ADDENDUM NO. 1

IFB TITLE: Sespe Creek Overflow Railroad Bridge Repair

IFB NO.: SPBL-2025-01

ADDENDUM SUMMARY

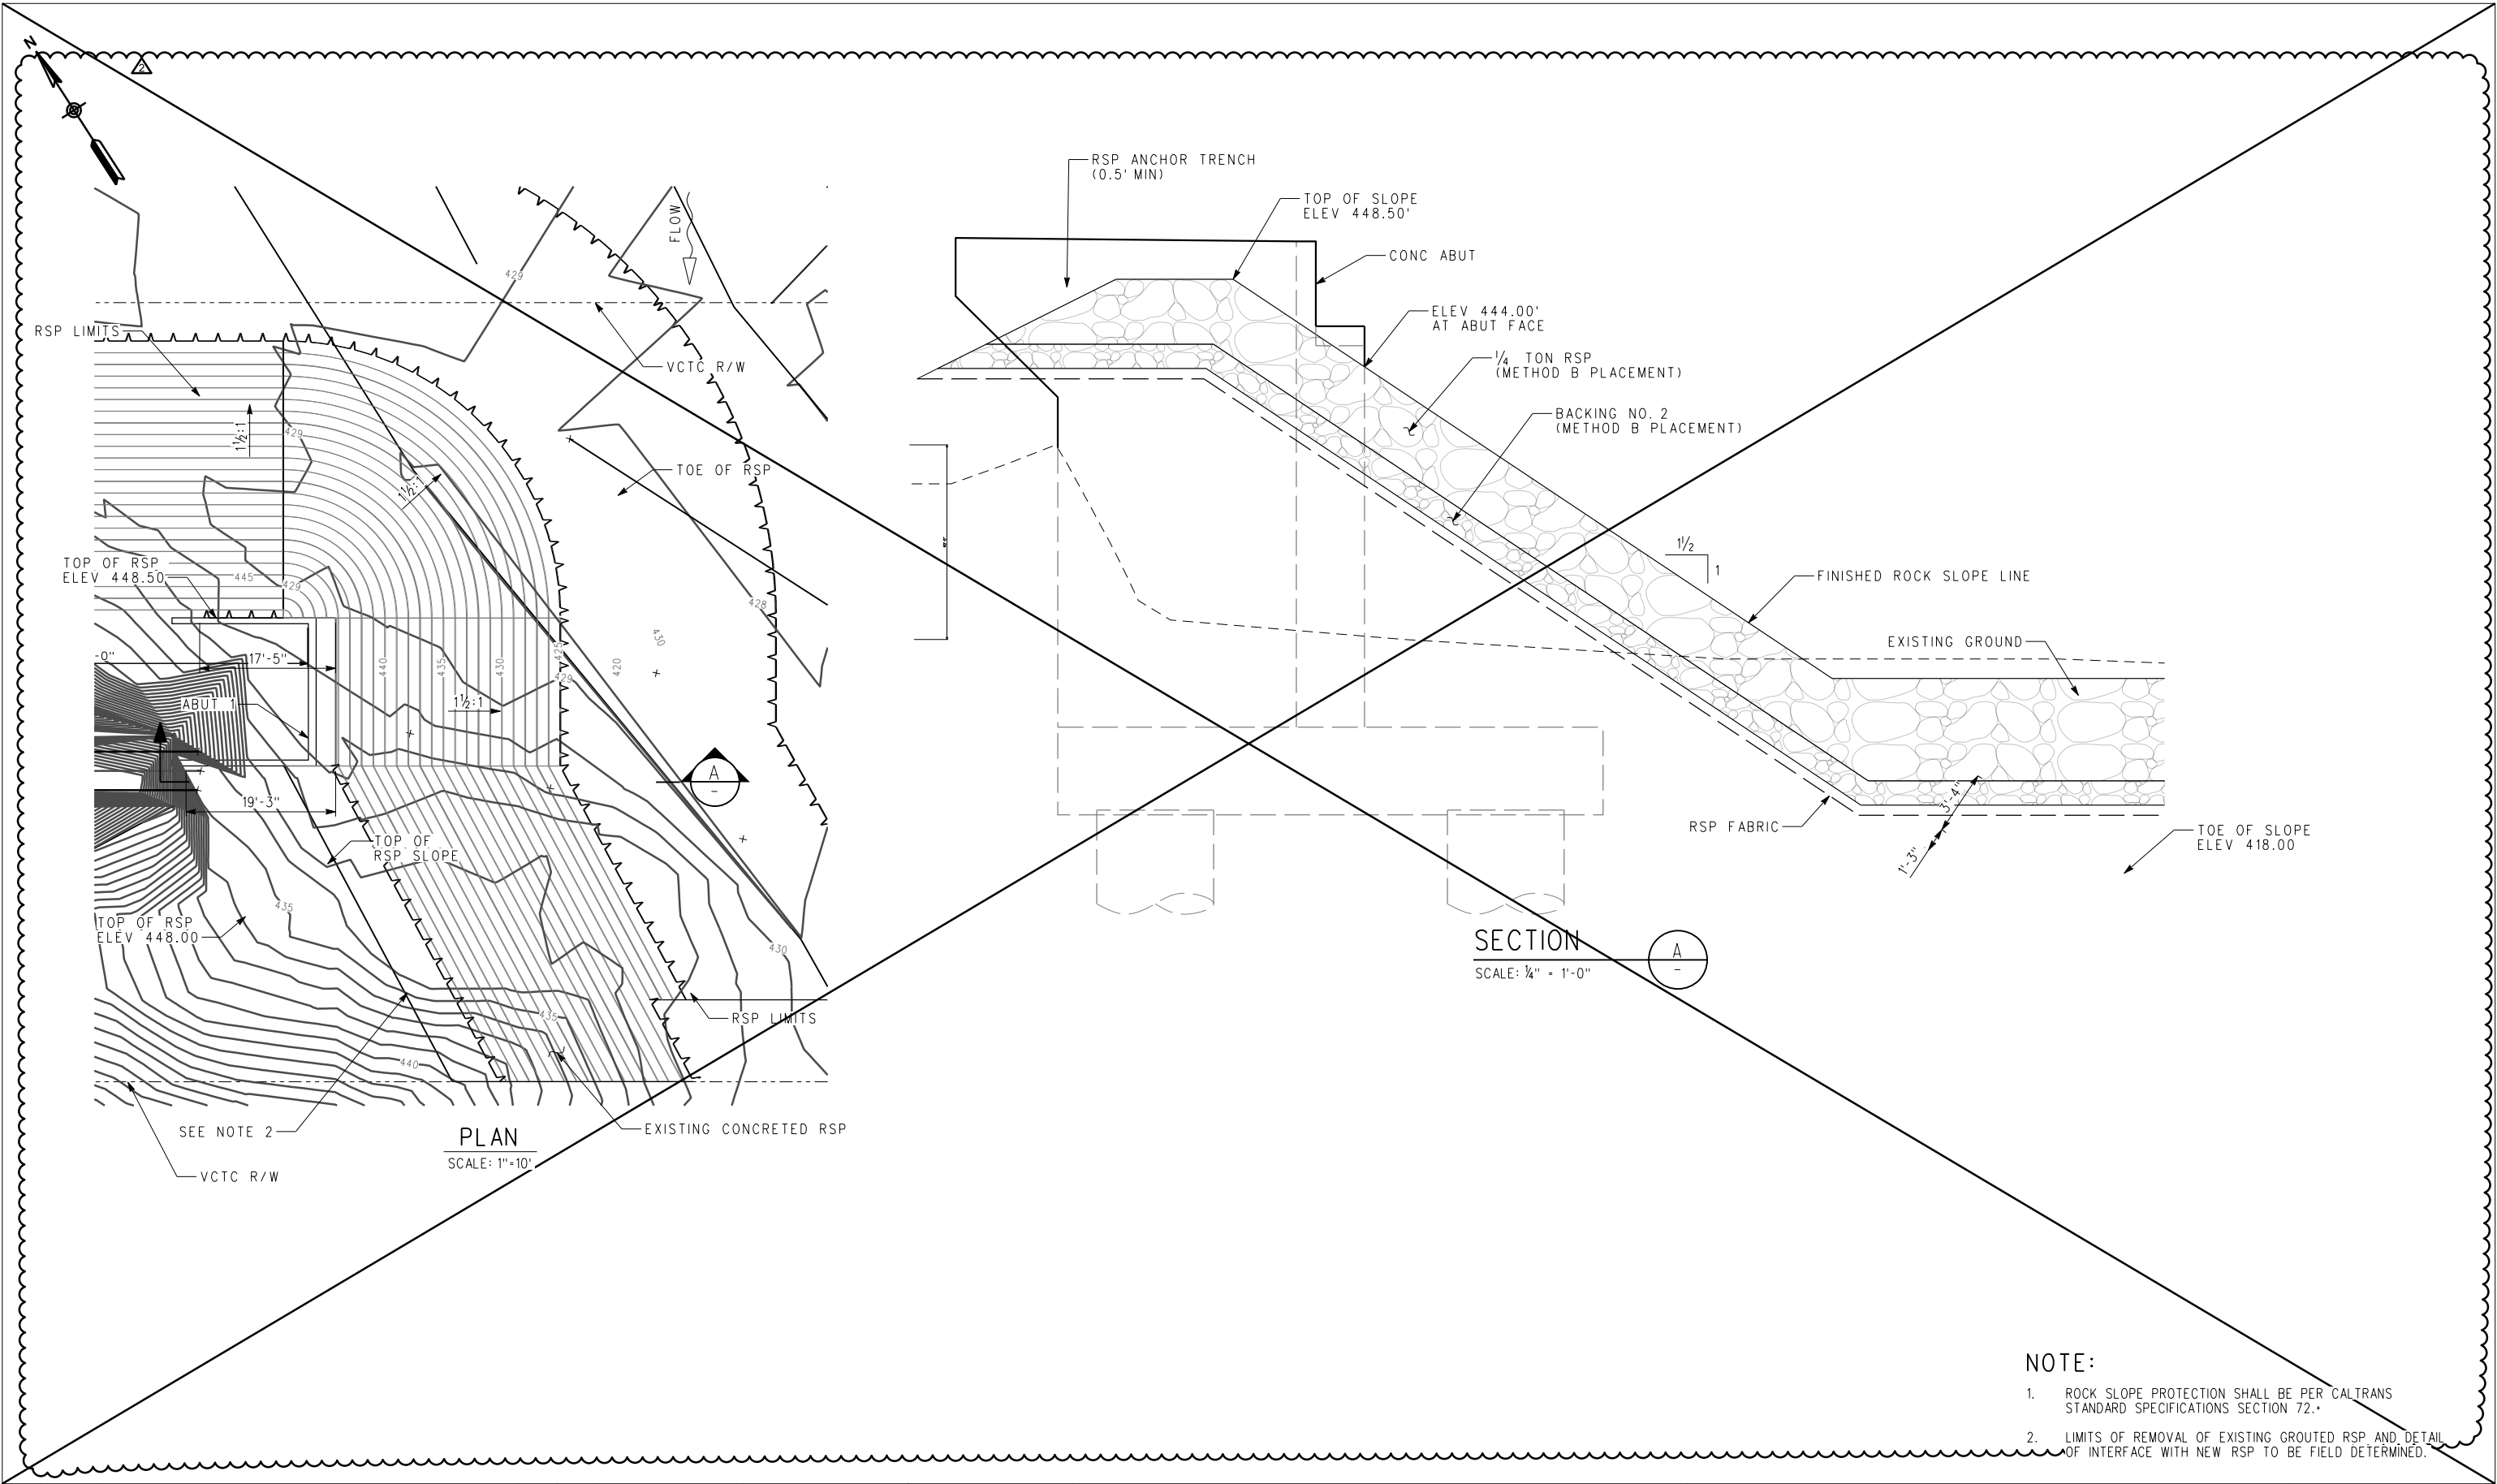
1. The Exhibit 3 Project Engineering Drawings has been revised for the following sheets:
 - G-002
 - RP-001
 - S-008
 - SC-001
 - SC-002
2. Sheet G-002 was updated to indicate the revised sheets.
3. Sheet RP-001 has been replaced.
4. Sheet S-008 has been voided and replaced by SC-002.
5. Sheet SC-001 has been voided and replaced by SC-002.

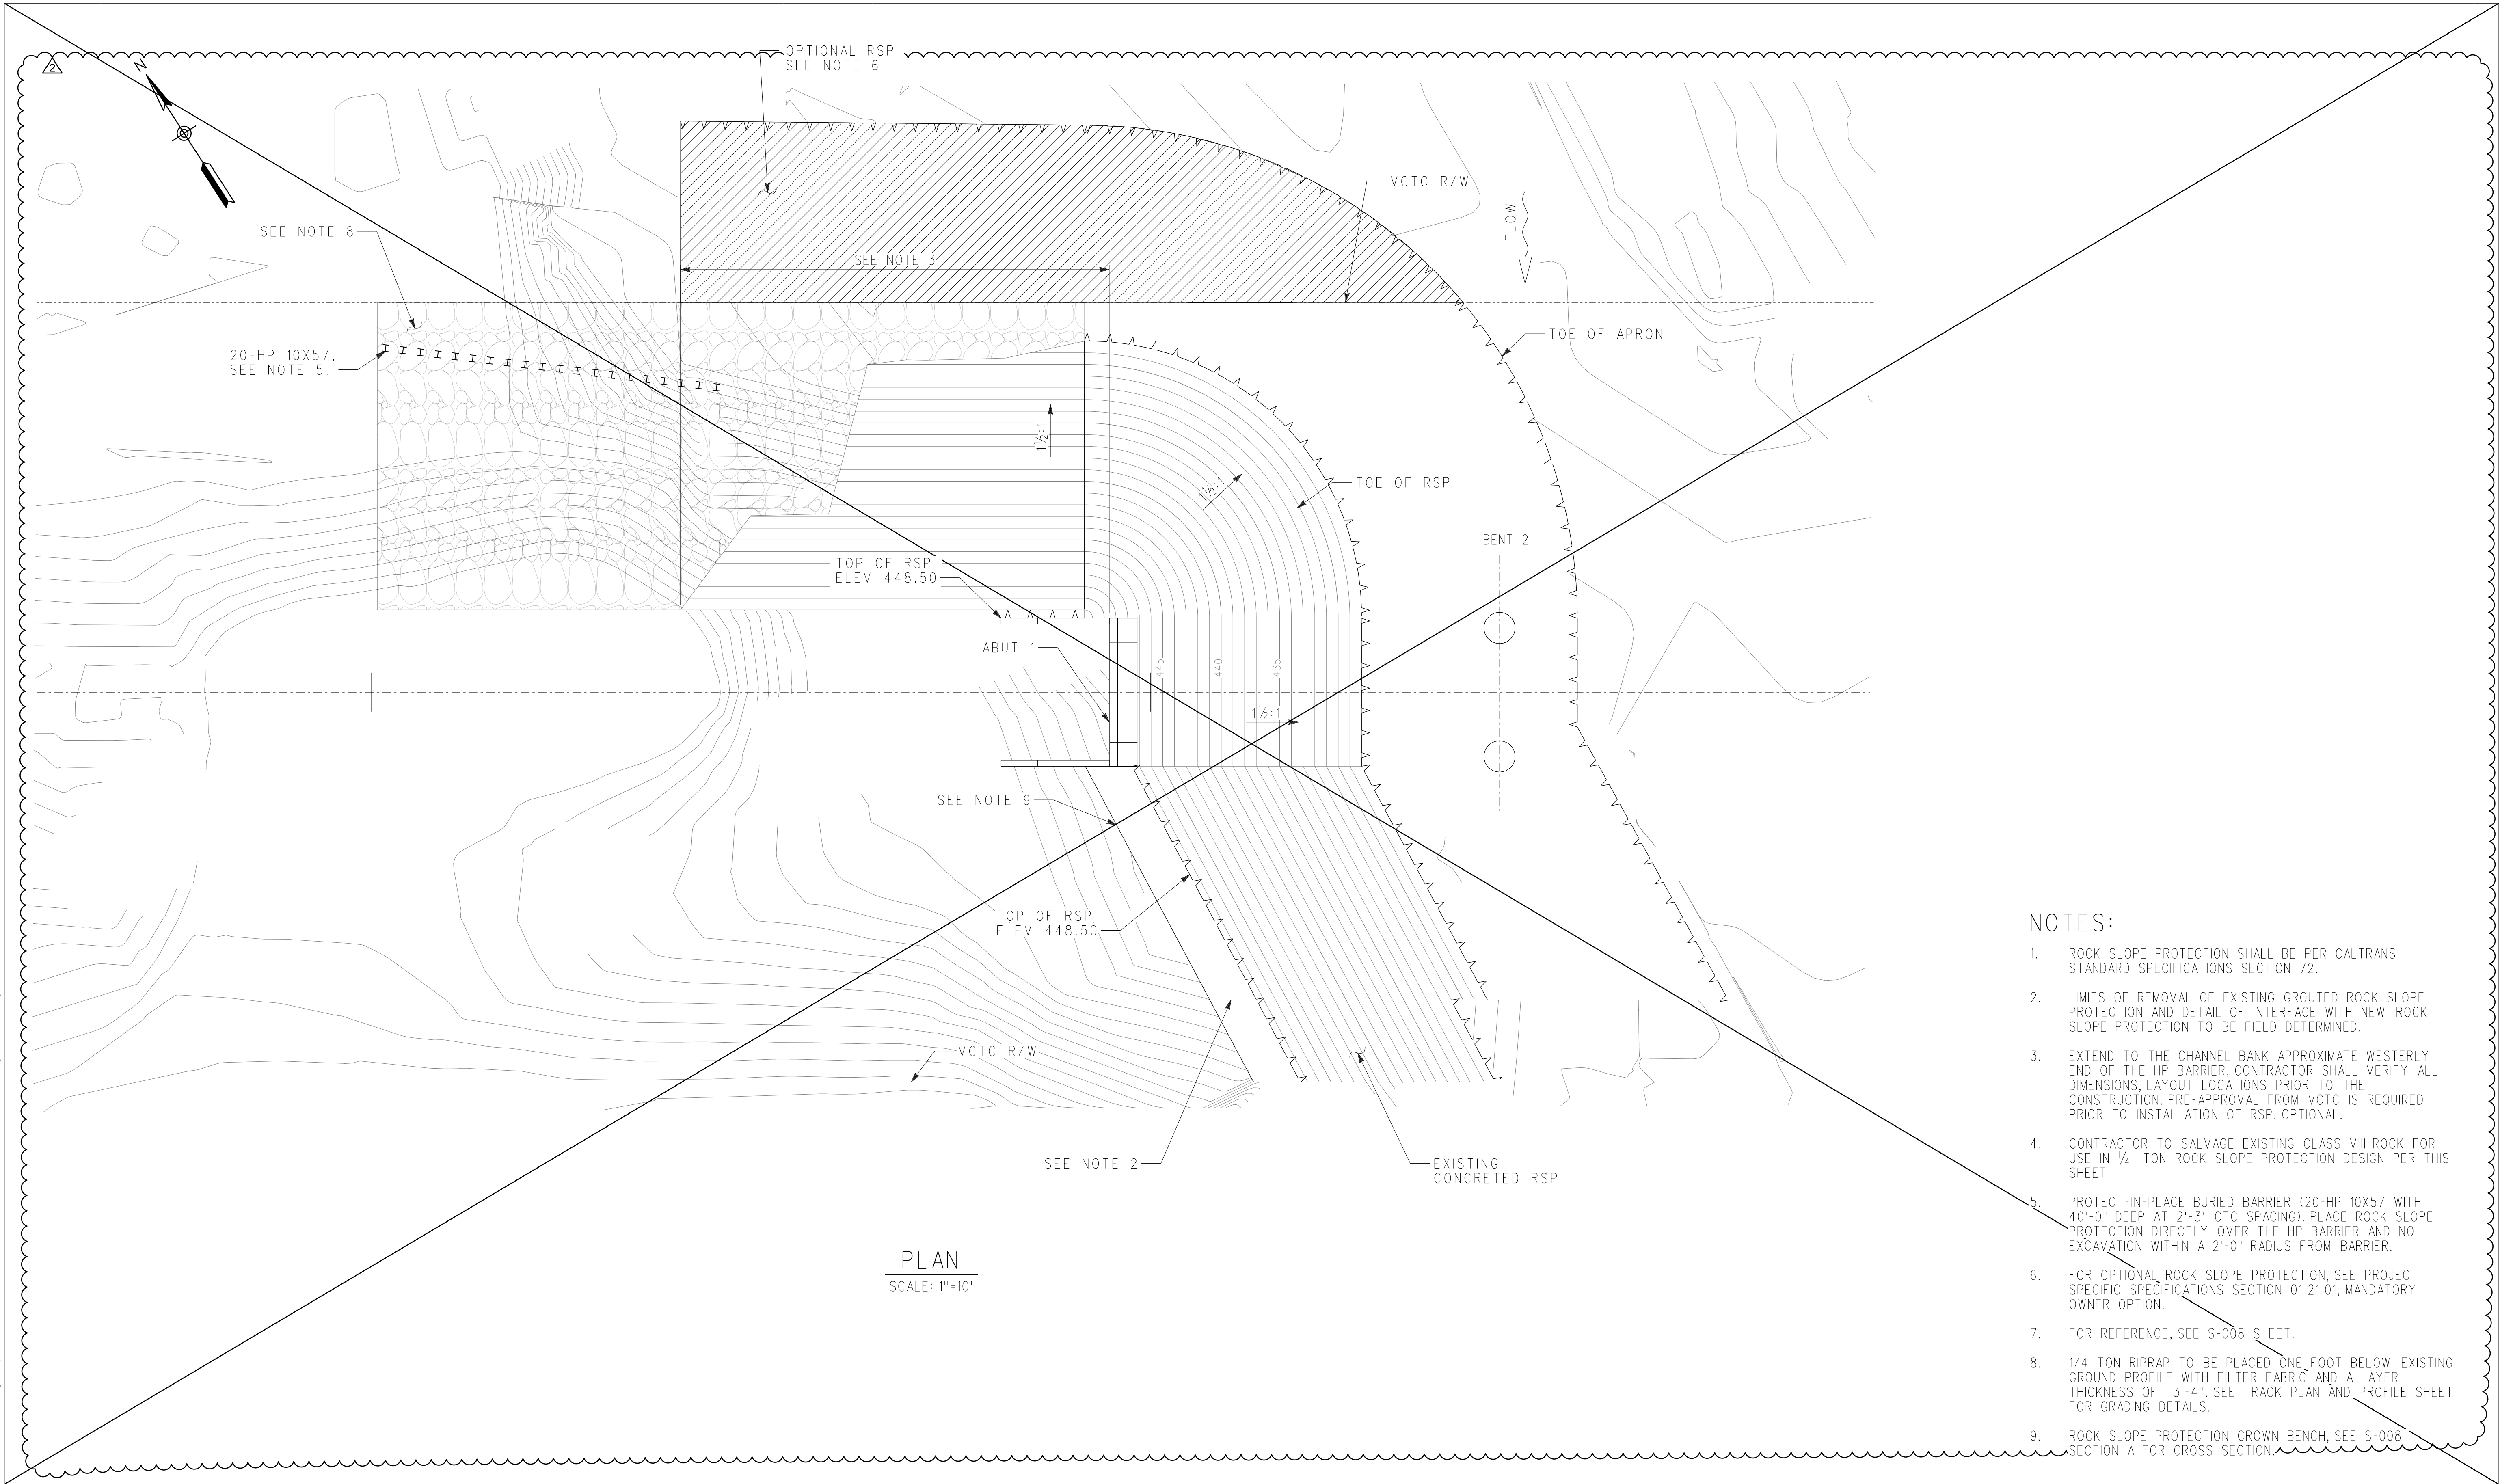
- NOTES:
- ROCK SLOPE PROTECTION SHALL BE PER CALTRANS STANDARD SPECIFICATIONS SECTION 72.
 - LIMITS OF REMOVAL OF EXISTING GROUTED ROCK SLOPE PROTECTION AND DETAIL OF INTERFACE WITH NEW ROCK SLOPE PROTECTION TO BE FIELD DETERMINED.

- EXTEND TO THE CHANNEL BANK APPROXIMATE WESTERLY END OF THE HP BARRIER, CONTRACTOR SHALL VERIFY ALL DIMENSIONS, LAYOUT LOCATIONS PRIOR TO THE CONSTRUCTION. PRE-APPROVAL FROM VCTC IS REQUIRED PRIOR TO INSTALLATION OF RSP, OPTIONAL.

- CONTRACTOR TO SALVAGE EXISTING CLASS VIII ROCK FOR USE IN 1/4 TON ROCK SLOPE PROTECTION DESIGN PER THIS SHEET.
 - PROTECT-IN-PLACE BURIED BARRIER (20-HP 10X57 WITH 40'-0" DEEP AT 2'-3" CTC SPACING). PLACE ROCK SLOPE PROTECTION DIRECTLY OVER THE HP BARRIER AND NO EXCAVATION WITHIN A 2'-0" RADIUS FROM BARRIER.

- FOR OPTIONAL ROCK SLOPE PROTECTION, SEE PROJECT SPECIFIC SPECIFICATIONS SECTION 0121 01, MANDATORY OWNER OPTION.
 - FOR REFERENCE, SEE S-008 SHEET.
 - 1/4 TON RIPRAP TO BE PLACED ONE FOOT BELOW EXISTING GROUND PROFILE WITH FILTER FABRIC AND A LAYER THICKNESS OF 3'-4". SEE TRACK PLAN AND PROFILE SHEET FOR GRADING DETAILS.

- ROCK SLOPE PROTECTION CROWN BENCH, SEE S-008 SECTION A FOR CROSS SECTION.
